## SECTION 8: RESPONSES TO COMMENTS ON DRAFT EIR

### 8.2 Responses to Comments on Previous Draft EIR

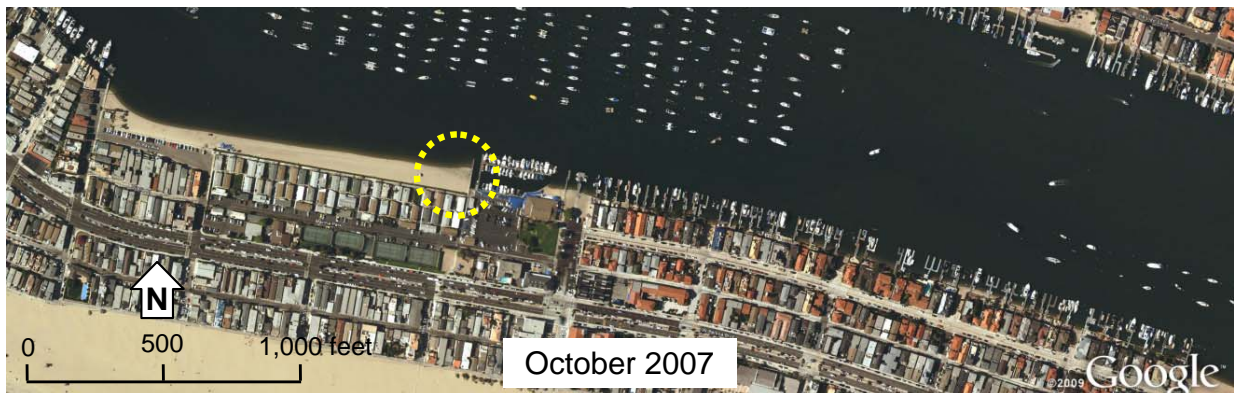
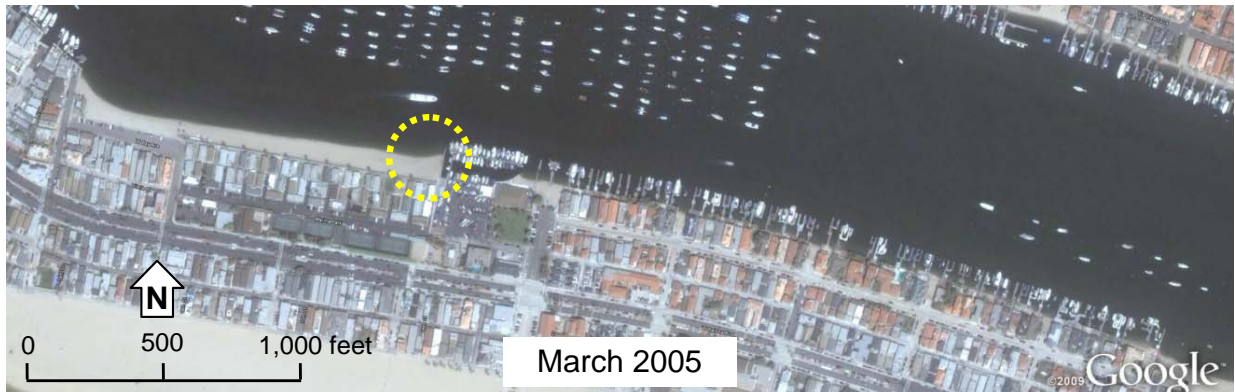
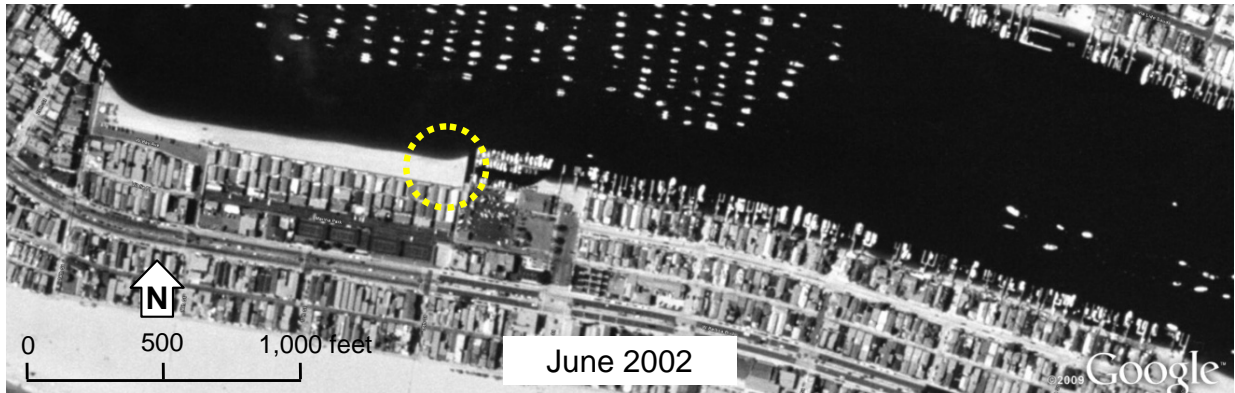
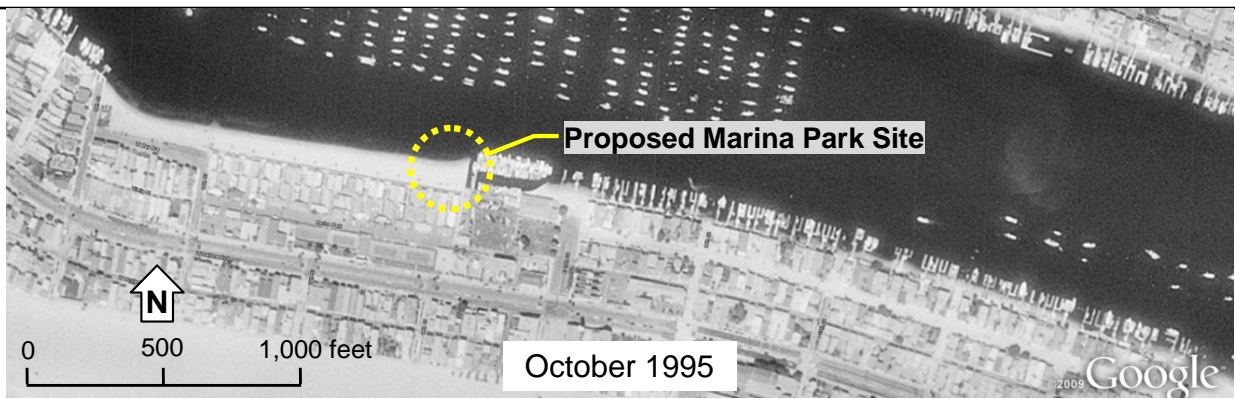
This comment expresses concern for the impact of the proposed groin wall on erosion and adjoining properties. In addition, this comment also asks for justification on the need of the proposed groin wall.

**Figure 8-2** shows a comparison of the proposed groin and its location relative to the existing groin. Since the proposed groin would have the same length as the existing groin and is located only about 350 ft west (upcoast) of the existing groin, it is expected that the proposed groin would have similar sand retaining characteristics, i.e., capable of maintaining a stable beach west of the proposed groin, and would have a similar (negligible) effect on the downcoast shoreline. The only direct impact of the proposed project would be the loss of the beach between the proposed and the existing groins; however, the existing beach would be widened to recapture a portion of the lost acreage. In addition, beach access would be improved with the proposed Marina Park, thereby providing improved coastal recreational opportunities for the community.

The proposed groin wall is needed to prevent the beach sand west of Marina Park from migrating into the marina basin. The proposed groin would have the same length as the existing groin, hence is expected to perform similarly as the existing groin. A particle tracking numerical model study (**Appendix H.2**) has shown that the proposed groin would provide similar protection to the proposed Marina Park marina basin as the existing groin provides to the American Legion marina. As discussed earlier, the existing groin has been shown to be effective in maintaining a

In summary, based on the experience of the American Legion marina and the numerical model study, the proposed groin for the Marina Park is needed to provide similar protection for the Marina Park marina as the existing groin to the American Legion marina. The new groin wall would also protect both the proposed marina as well as the American Legion marina.

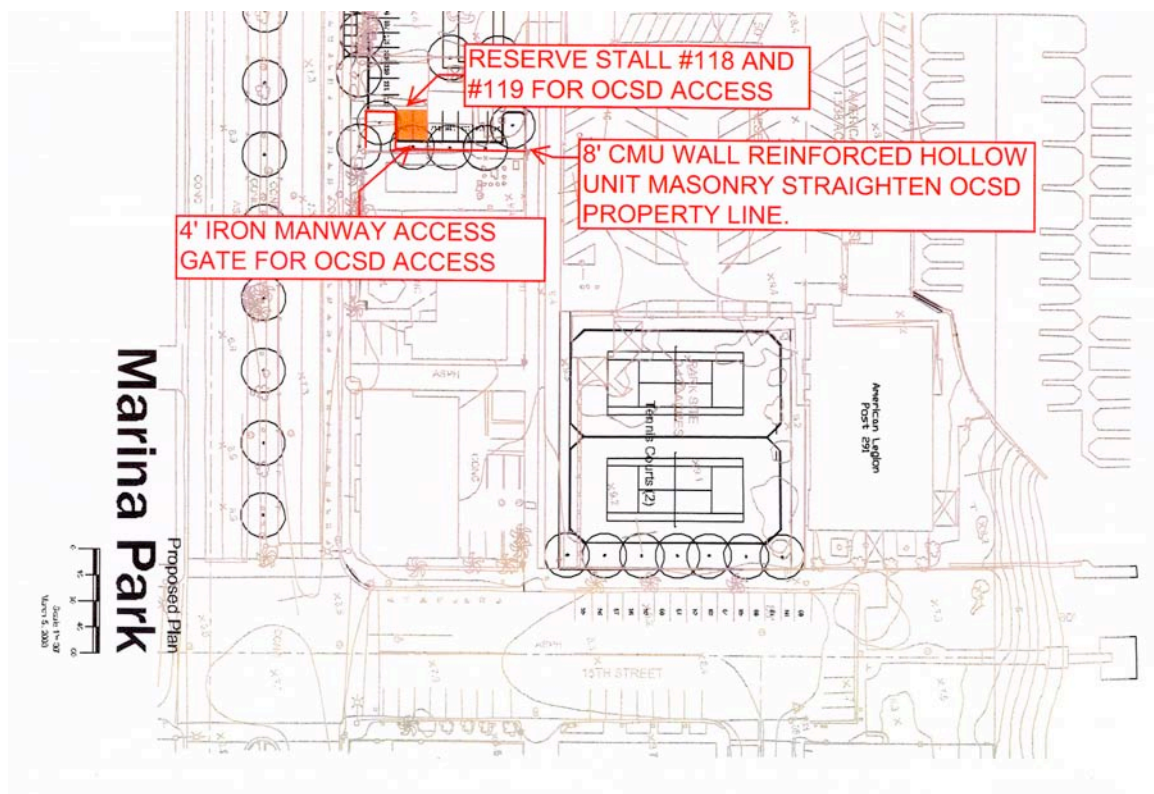
This comment requests that the Draft EIR address increased traffic to 15<sup>th</sup> Street through the alley parallel to Balboa Boulevard. The alley is a secondary access to the approximately 133 parking spaces adjacent to the Balboa Center Complex. As shown on Table 5.11-3, the proposed uses would result in a maximum of 46 peak hour trips to the site (i.e., via the 16<sup>th</sup> Street entrance). Although the proposed parking lot includes an adequate number of spaces to accommodate the

proposed uses, it is anticipated that there would be increases in traffic along the alley that parallel Balboa Boulevard. The existing alley has adequate capacity to accommodate potential increases in traffic. In regards as to how this increased traffic would impact access to the OCSD pumping station refer to Response to Comment A8-3, below.
